REVISED RESPONSE TO REQUEST FOR ADDITIONAL INFORMATION

APR1400 Design Certification

Docket No. 52-046

RAI No.: 356-7881

Figure 7.5-2 QIAS-N Block Diagram

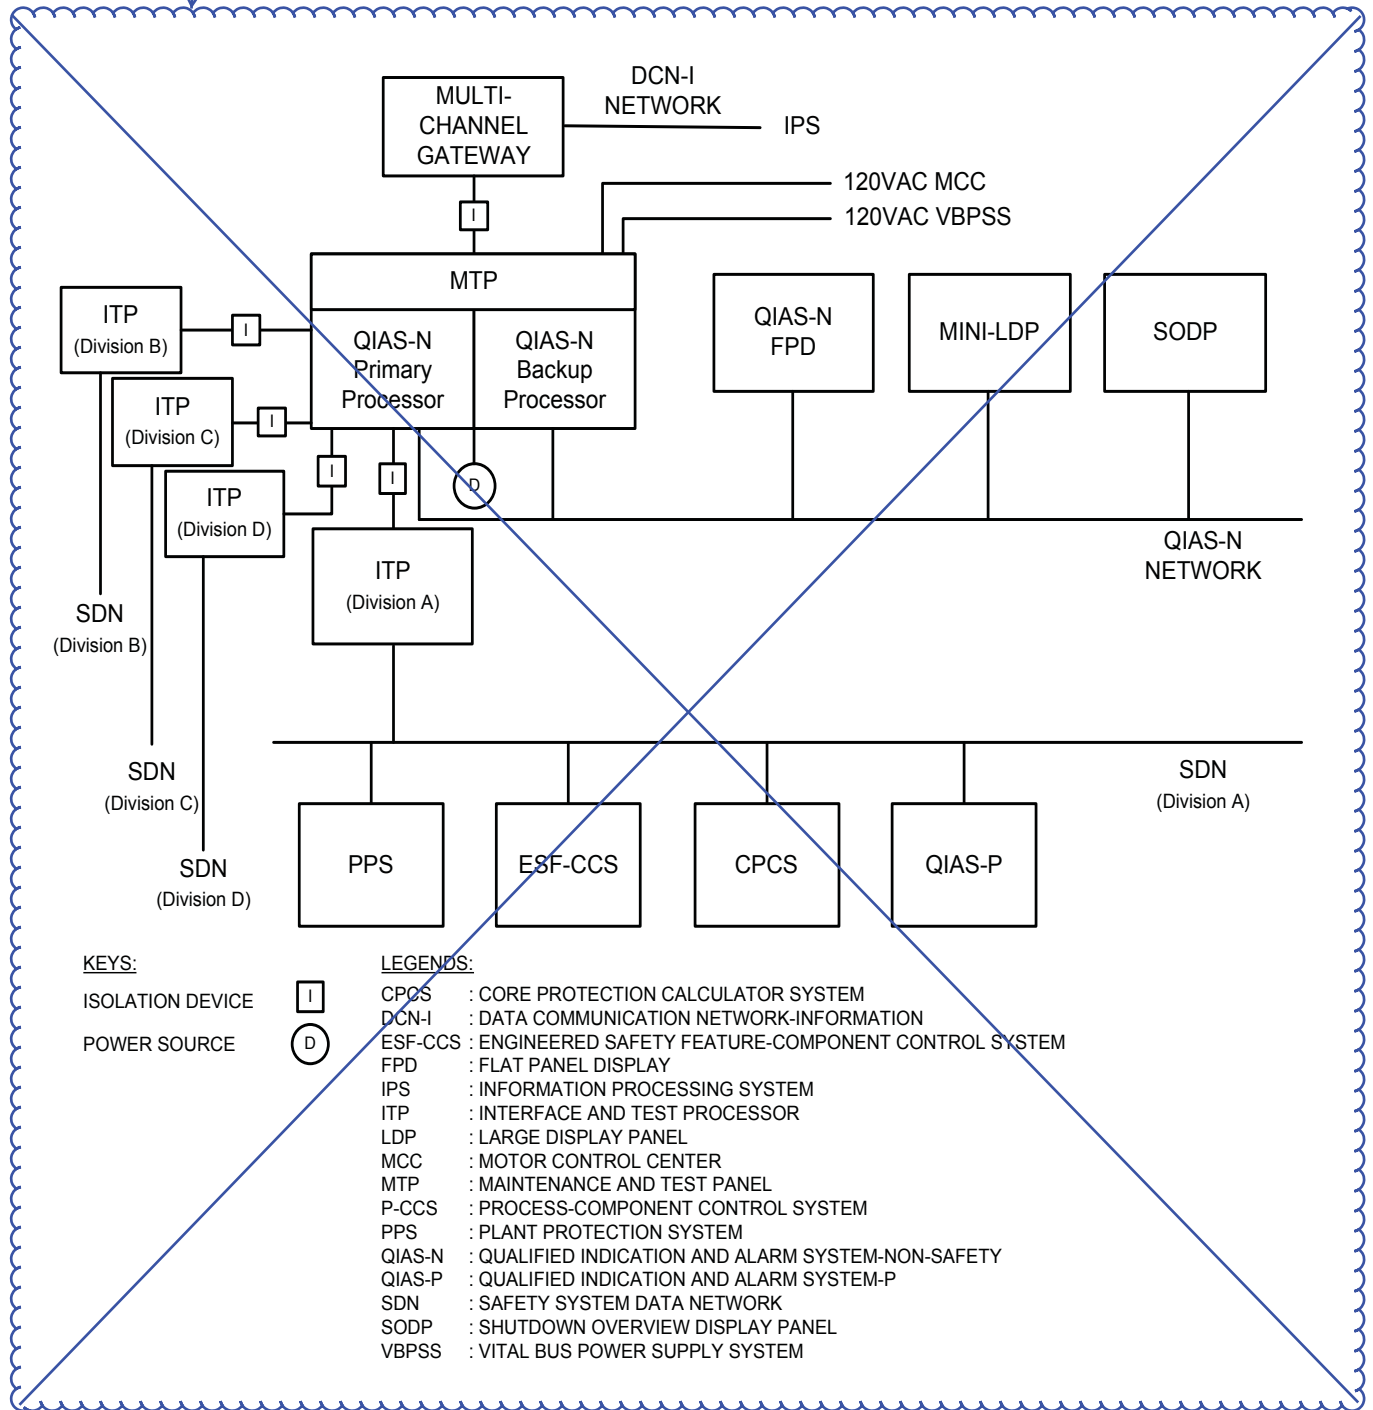
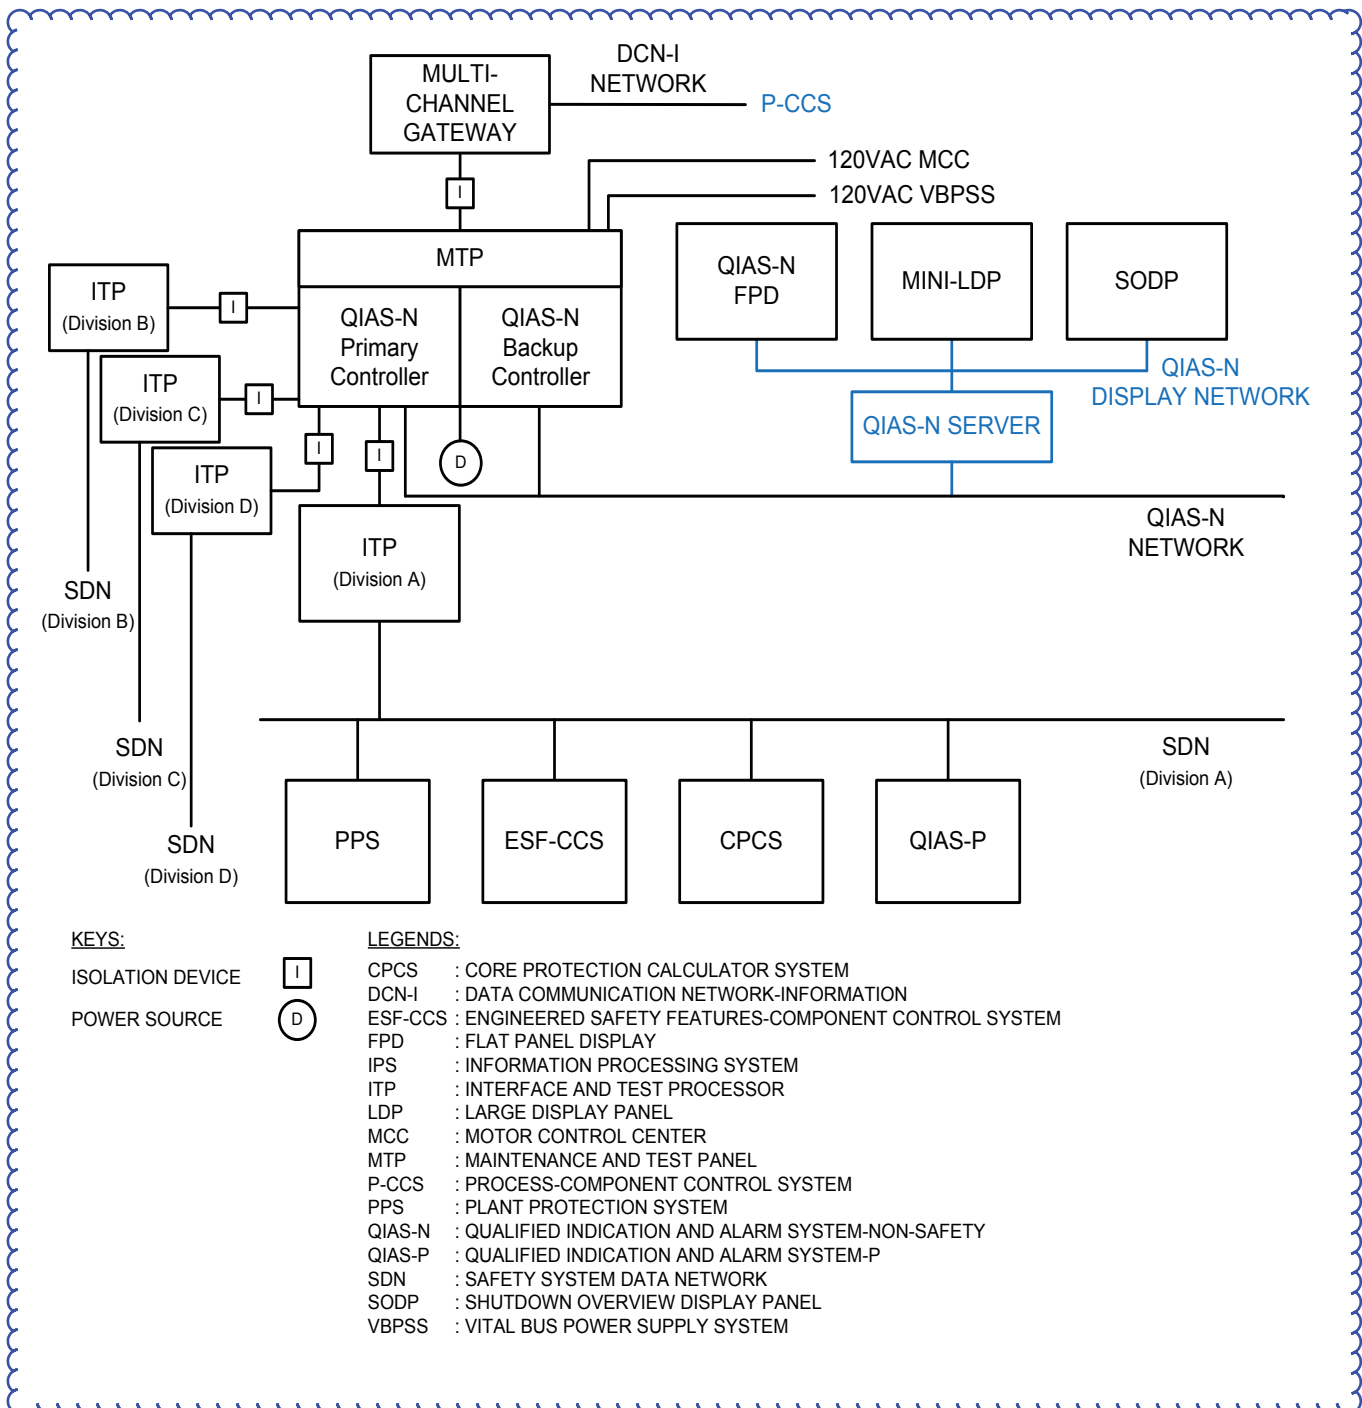
Describe the mechanisms, procedures, or processes in place for the APR1400 design that would allow operators to be alerted to a failure of either the QIAS-N or the IFPDs (e.g. frozen displays or controls).

← The block diagram for the QIAS-N is shown in Figure 7.5-2.

Each QIAS-N redundant processors and networks are designed such that the fail-over to the backup processor is accomplished without interrupting the information being displayed, as shown in Figure 7.5-2. Isolation devices are used between the ITP and QIAS-N.

The QIAS-N processor receives safety system signals via the ITP. The QIAS-N MTP receives non-safety system signals via the multi-channel gateway. Isolation devices are used between the ITP and QIAS-N processor, and between the multi-channel gateway and QIAS-N MTP. The QIAS-N processor performs applicable calculations based on the data received from the safety systems and non-safety systems. The QIAS-N MTP provides maintenance and testing means of the QIAS-N, and a gateway function with the multi-channel gateway to provide communication from the non-safety P-CCS. The QIAS-N server contains the process database, updates the values and status of the database records, executes the alarm processing function, and functions as a gateway between the QIAS-N network and QIAS-N display network.

The data from the QIAS-N processor (safety system signals) and the data from the QIAS-N MTP (non-safety system signals) are broadcasted on the QIAS-N network. The QIAS-N server captures the data from the QIAS-N network and updates the QIAS-N process database. The QIAS-N server broadcasts them on the QIAS-N display network for indication on the QIAS-N displays (QIAS-N FPDs, mini-LDPs, and SODPs).

In addition, the QIAS-N server provides system diagnostic functions as follows:

- a. Monitor the QIAS-N MTP, QIAS-N processor, QIAS-N network, QIAS-N display network.
- b. Detect QIAS-N trouble and generate QIAS-N trouble status signals.
- c. Transfer the QIAS-N trouble status to the non-safety IPS for alarm purpose.
- d. Transfer the QIAS-N trouble status to the QIAS-N MTP via QIAS-N network for indication on the QIAS-N MTP displays.
- e. Transfer the QIAS-N trouble status to the QIAS-N FPDs, mini-LDPs, and SODPs via QIAS-N display network.

Figure 7.9-1 Data Communication Block Diagram

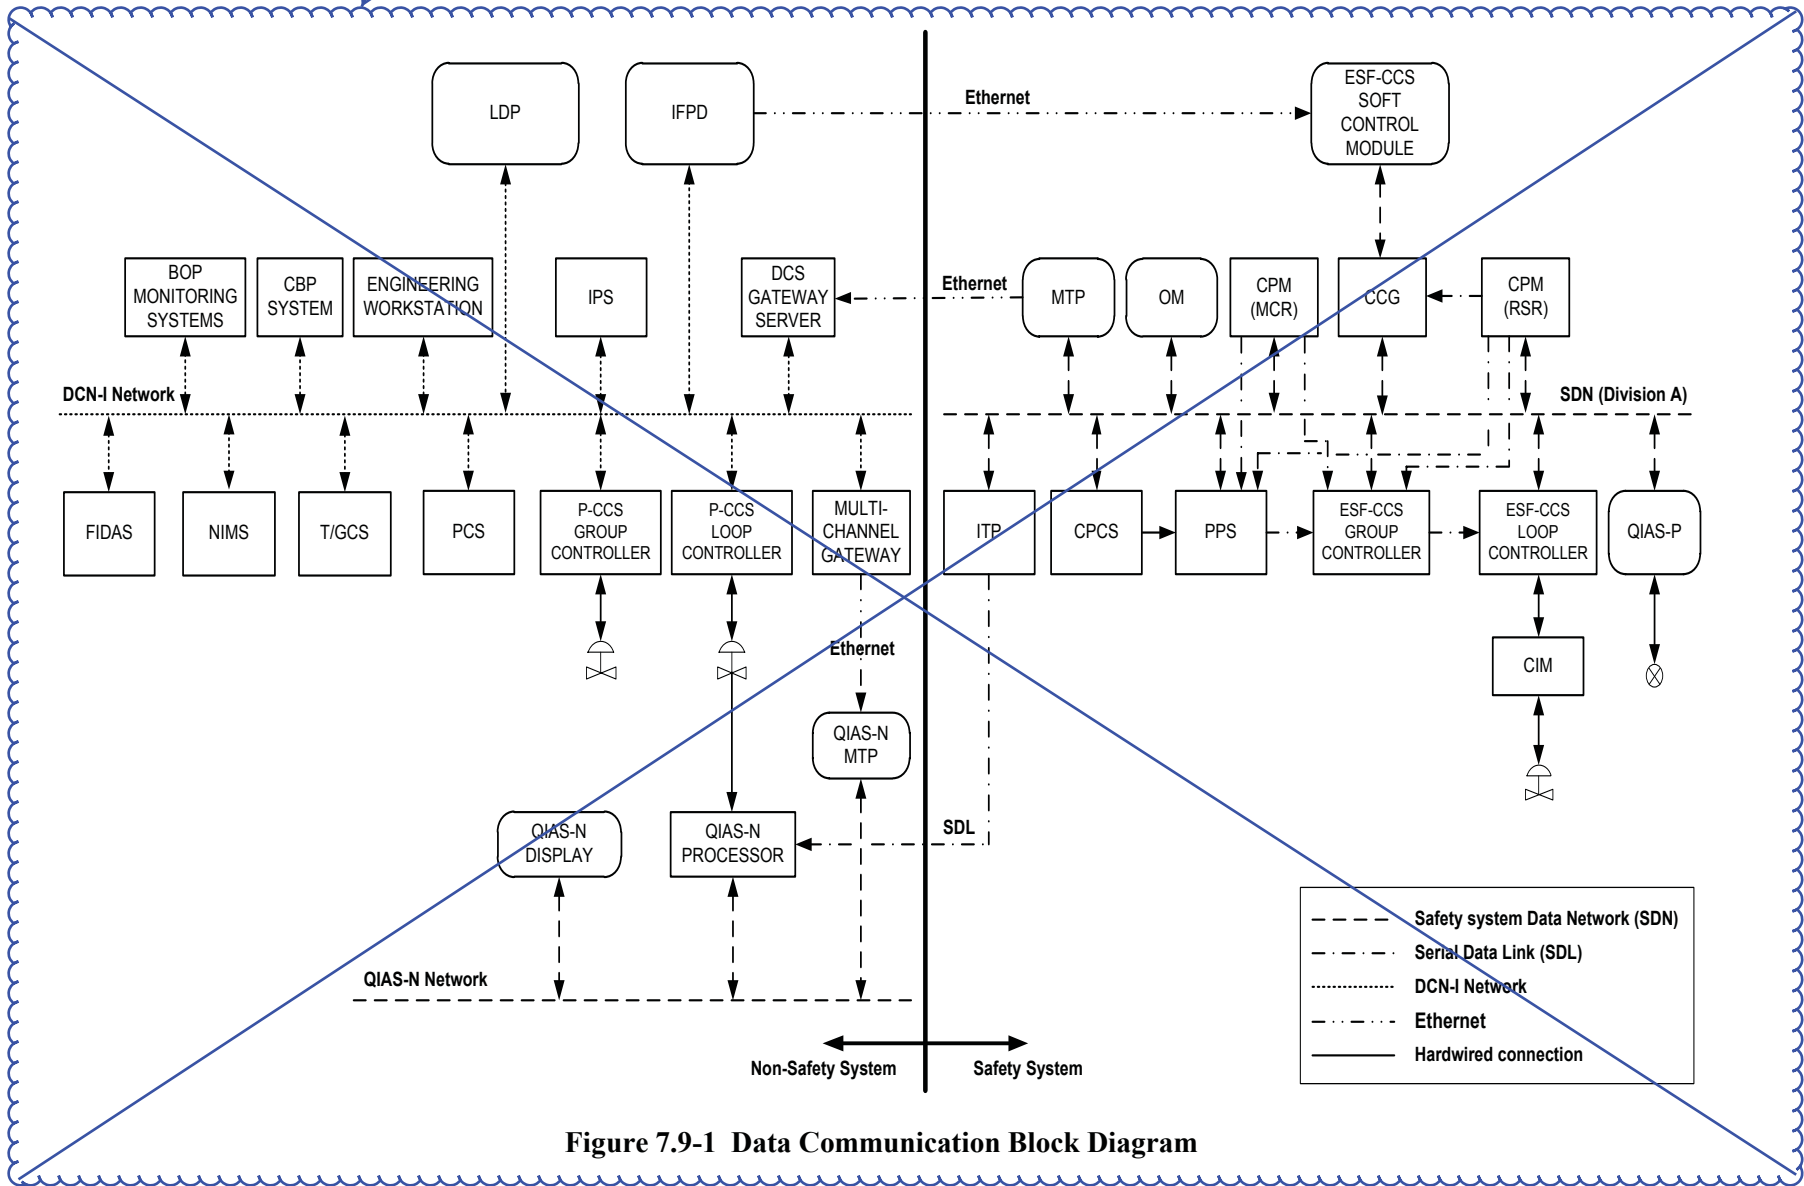
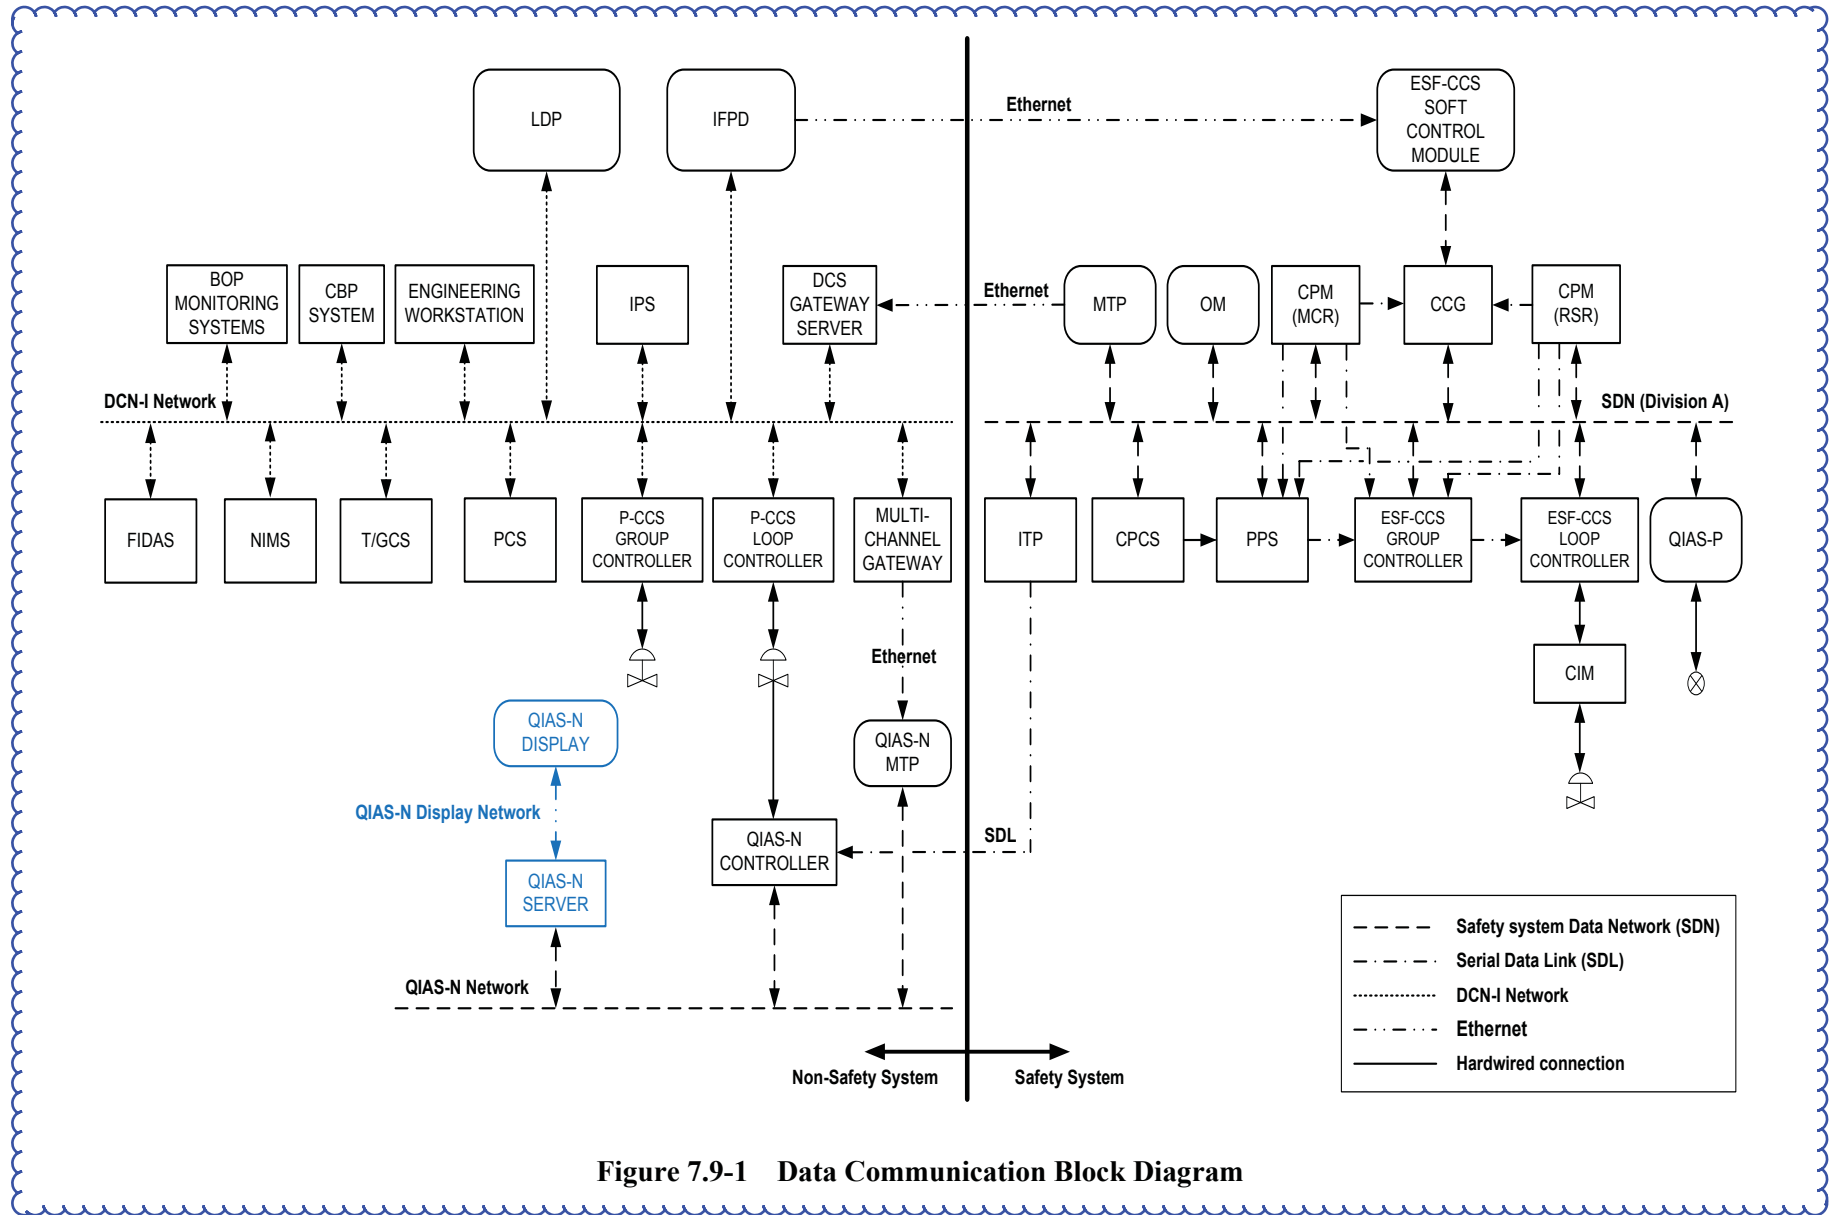
The APR1400 DCD Tier 2, Subsection 7.5.1.1, Figure 7.5-2, and Figure 7.9-1 will be revised as indicated in the Attachment associated with this response.
